NSW Site Auditor Scheme SITE AUDIT STATEMENT

Site audit statement no. **149B**

Address **Fort Wallace, Fullerton Street, Stockton, NSW**

1.1 Purpose

Figure 2 Location of Proposed Landuse Areas

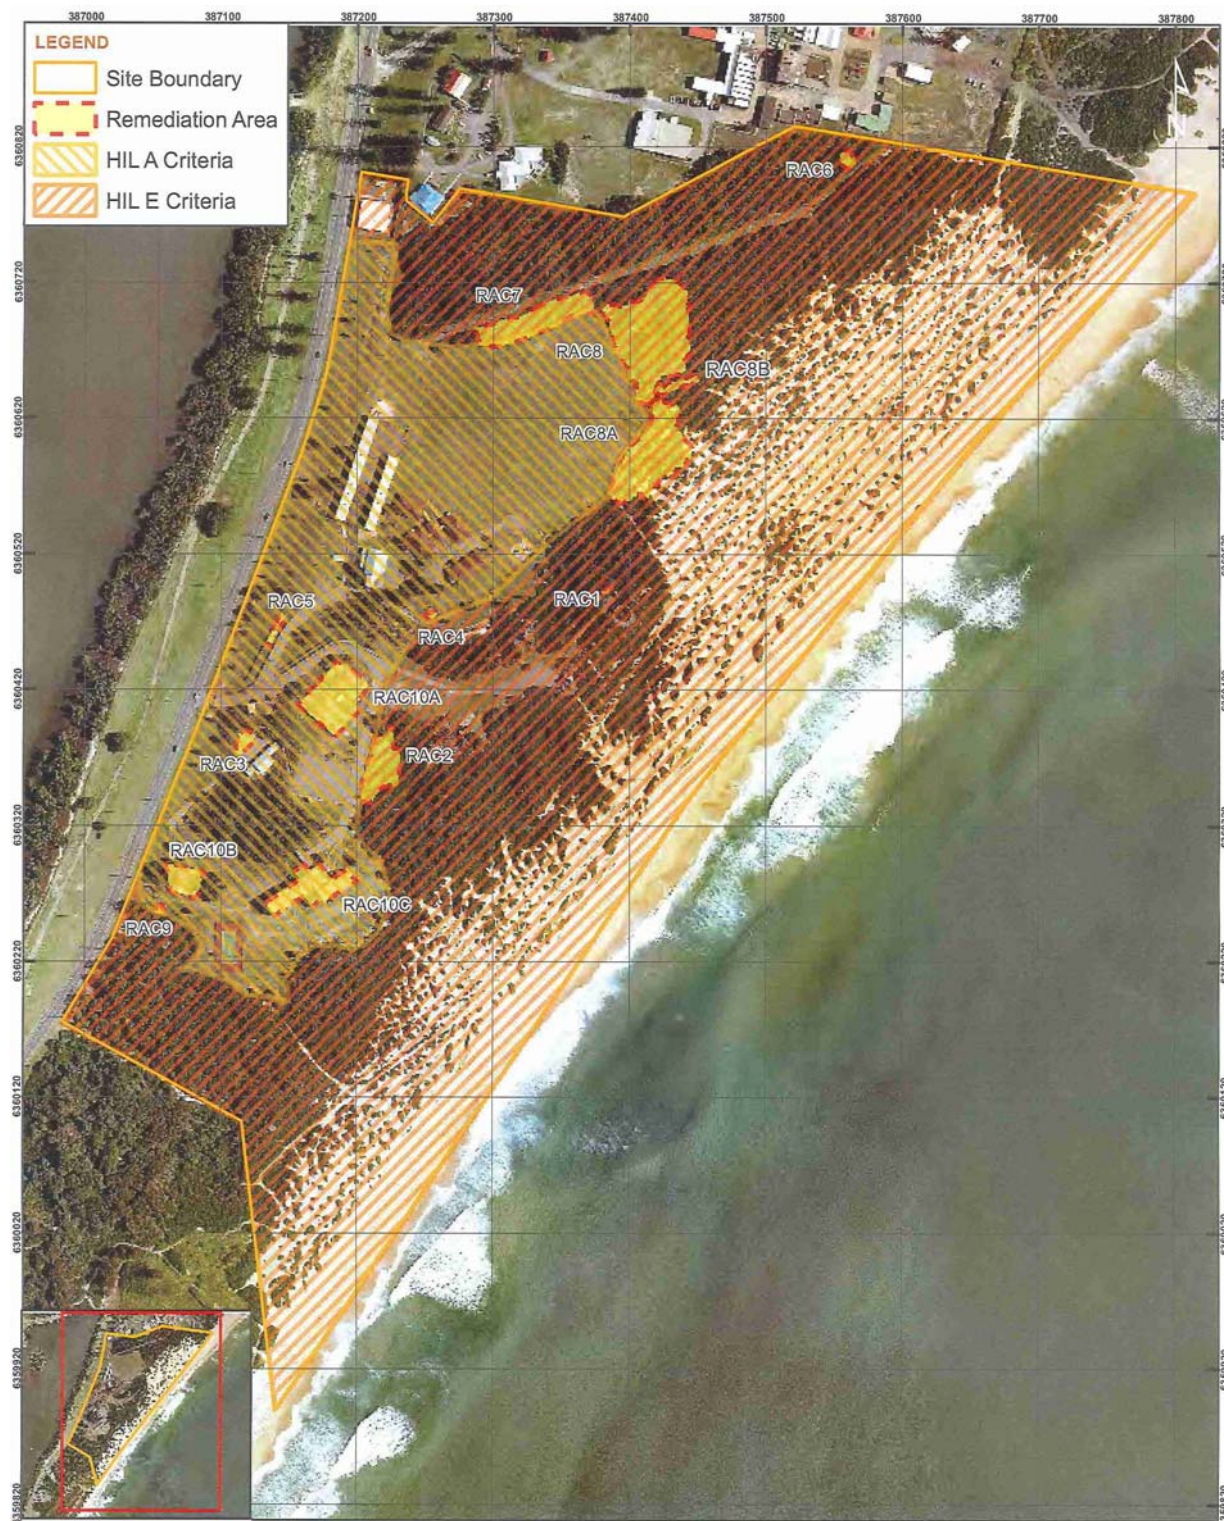
- ☒ I certify that, in my opinion, the **“unrestricted landuse”** portion of the site (refer Figure 2) is **SUITABLE** for the following use(s) (*tick all appropriate uses and strike out those not applicable*):

- ☒ I certify that, in my opinion, the **“non-development landuse”** portion of the site (refer Figure 2) is **SUITABLE** for the following use(s) (*tick all appropriate uses and strike out those not applicable*):

■ Figure 3 Location of Proposed Landuse Areas

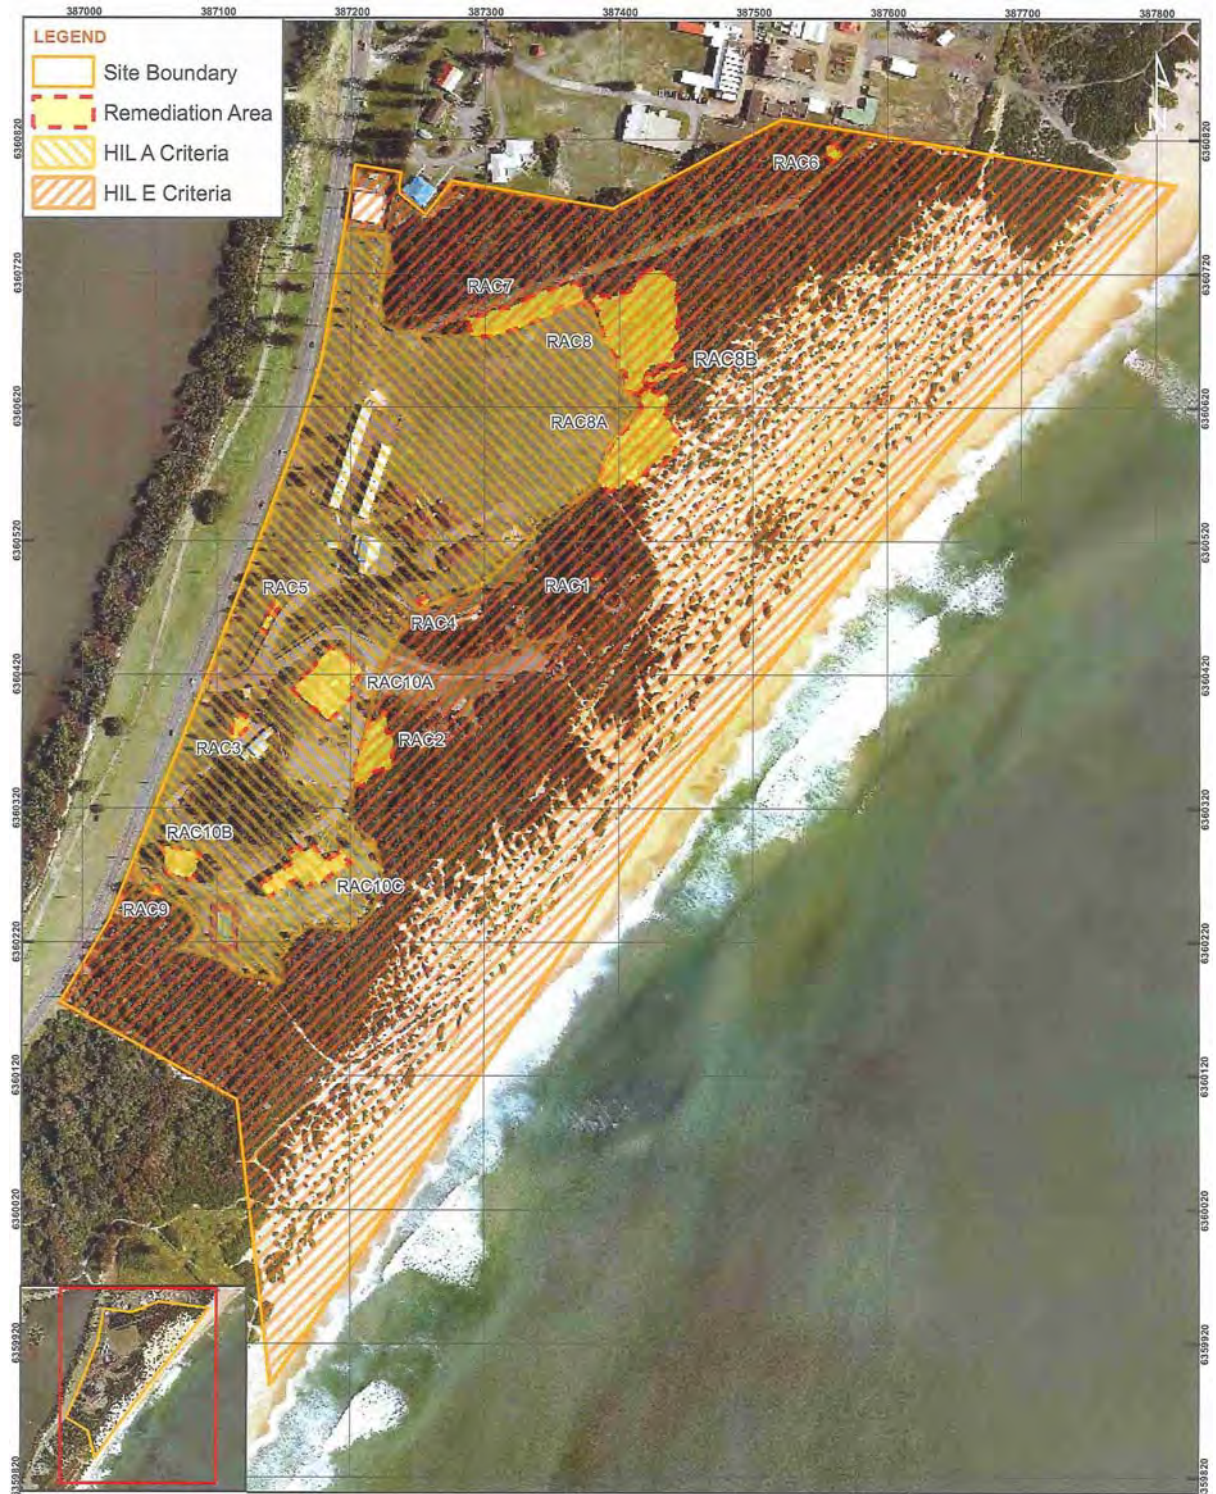
The Site Auditor considers available information supports the conclusion that the “*unrestricted landuse*” area, as shown in **Figure 3**, meets NSW DECCW requirements and is suitable for the following NEPM land use categories provided the Site is managed in accordance with the SEMP:

The Site Auditor considers available information supports the conclusion that the “*non-development landuse*” area, as shown in **Figure 3**, meets NSW DECCW requirements and is suitable for the following NEPM land use categories provided the Site is managed in accordance with the SEMP:

■ **Figure 5 Location of Asbestos Clearance Areas**

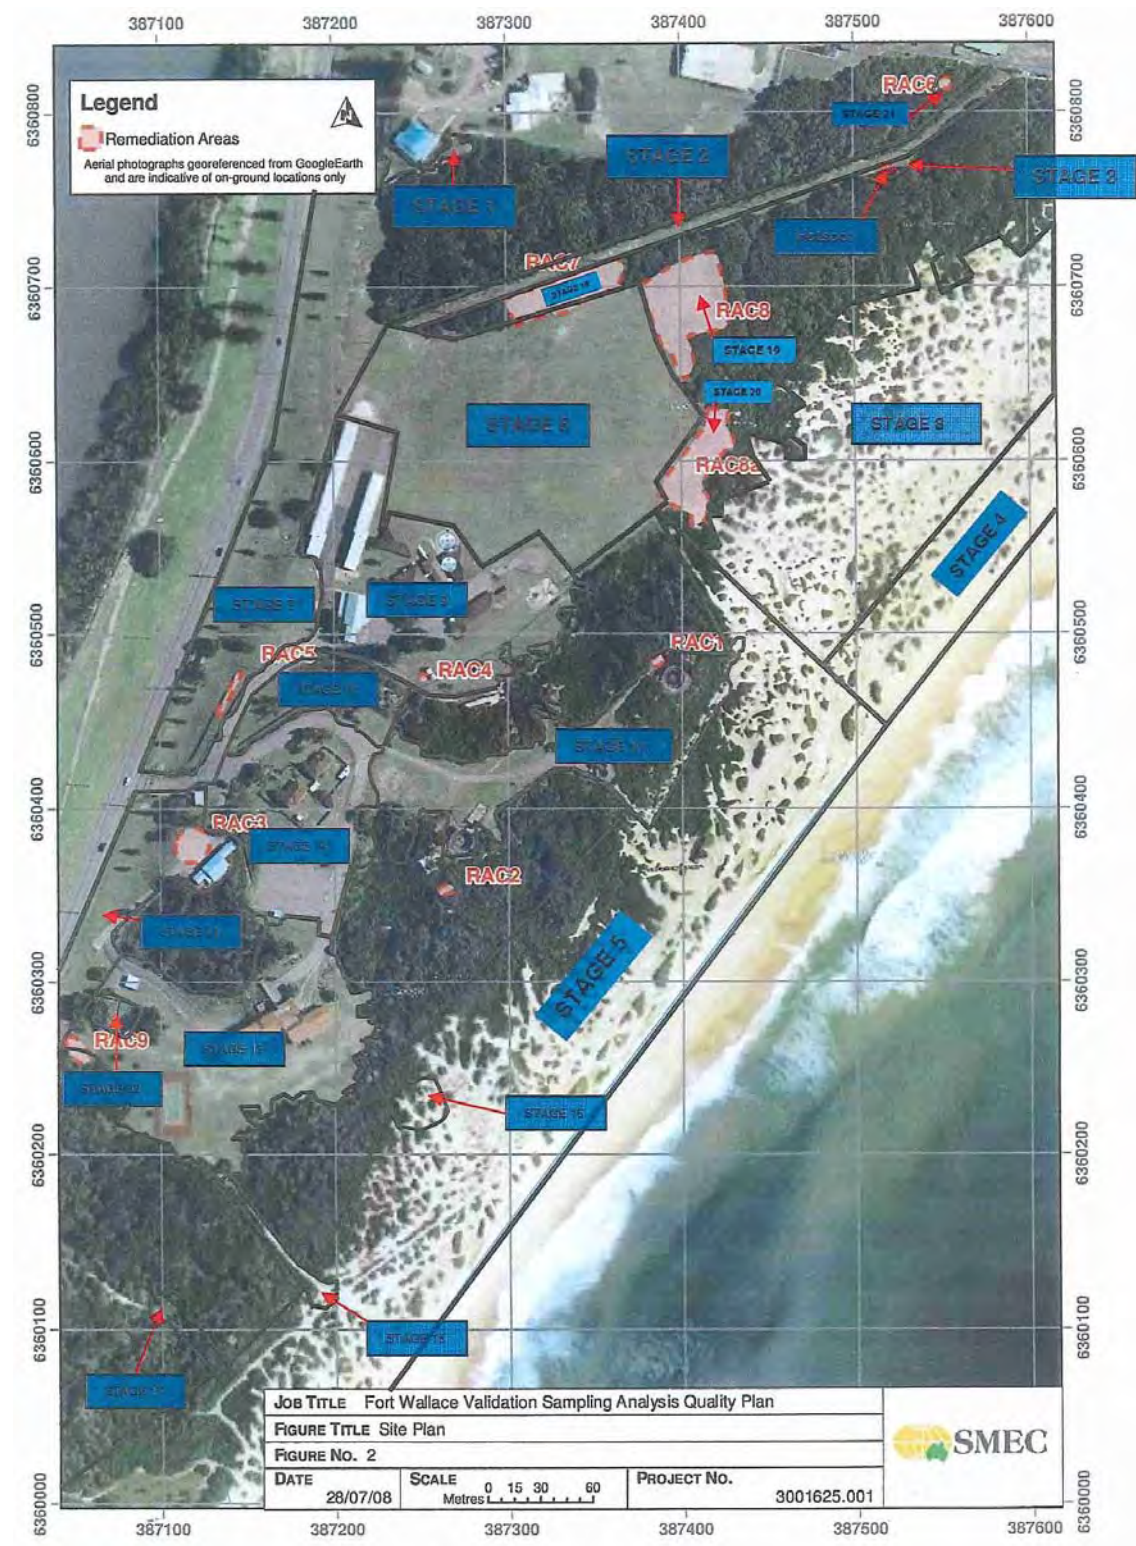
The ACM clearance program divided the Site up into a number of stages, which are shown in **Figures 5** and **6**, with a summary of the certification provided in **Table 3-6**. **Figure 6** also shows the locations where the occupational hygienist undertook emu-picking across the Fort Wallace site.

Figure 2 Location of Proposed Landuse Areas

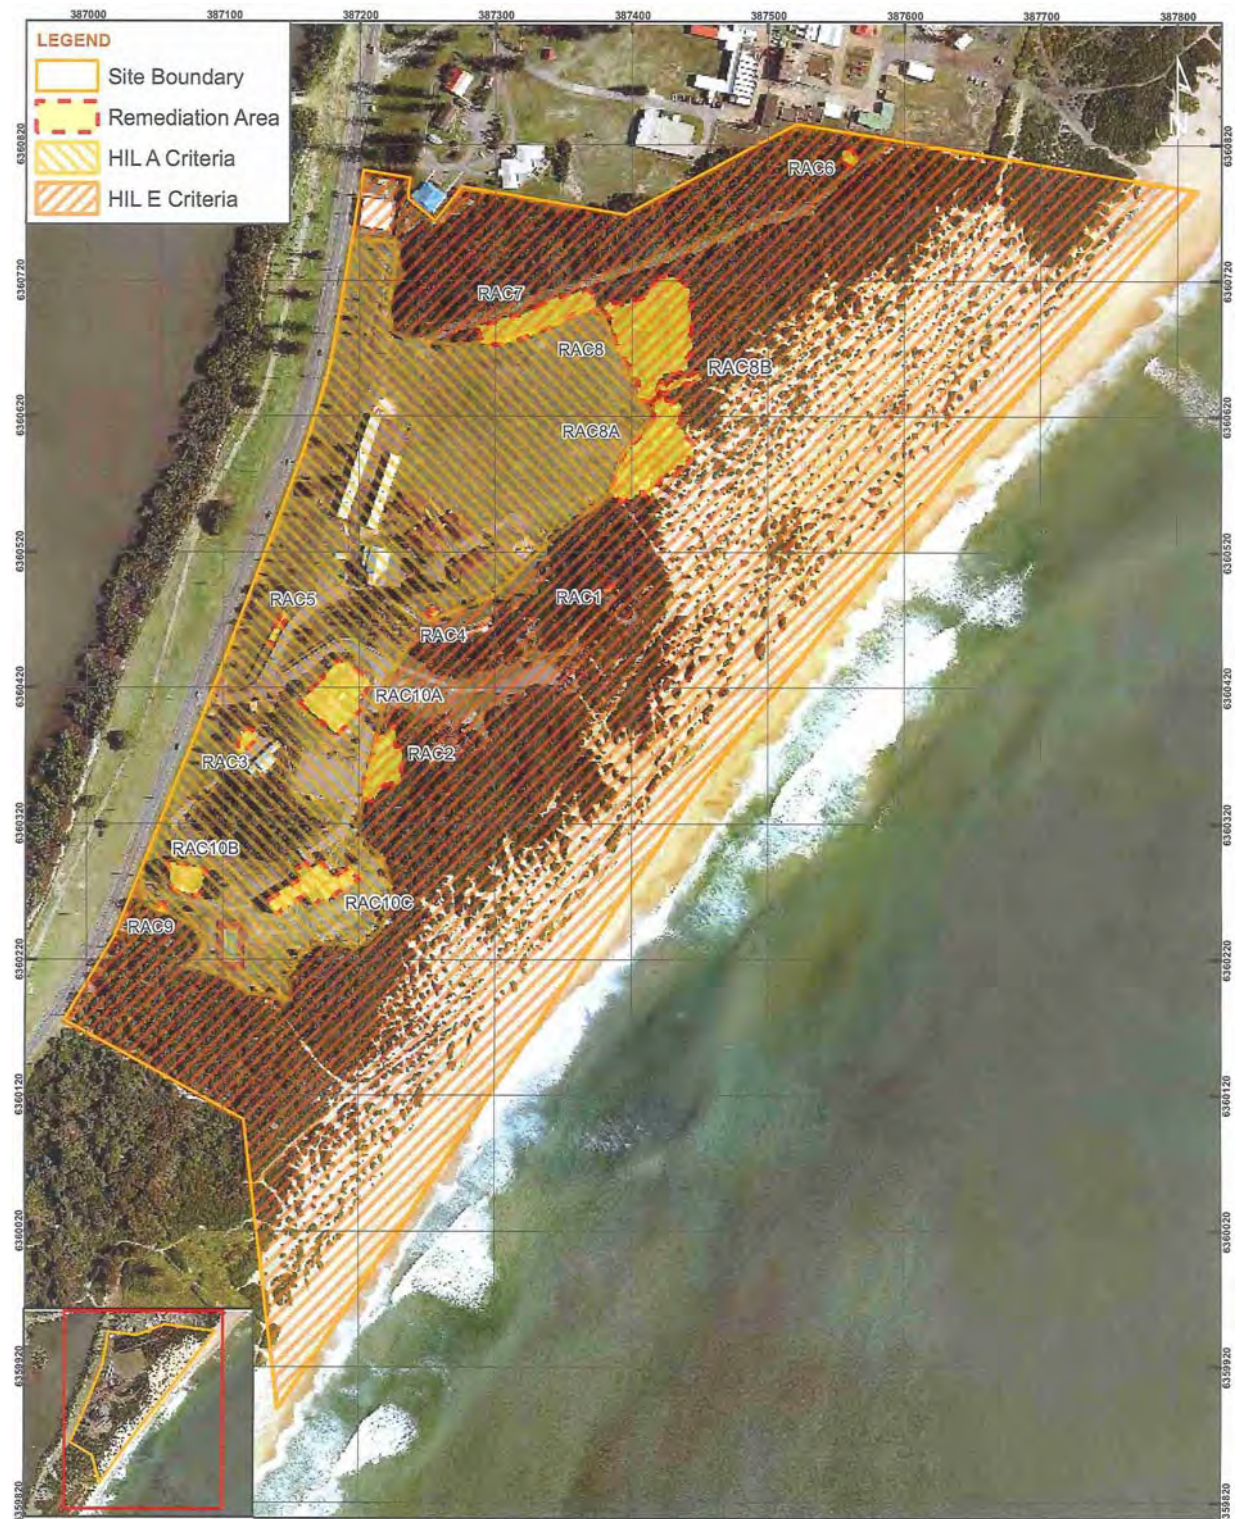
- ☒ I certify that, in my opinion, the **“unrestricted landuse”** portion of the site (refer Figure 2) is **SUITABLE** for the following use(s) (*tick all appropriate uses and strike out those not applicable*):

- ☒ I certify that, in my opinion, the **“non-development landuse”** portion of the site (refer Figure 2) is **SUITABLE** for the following use(s) (*tick all appropriate uses and strike out those not applicable*):
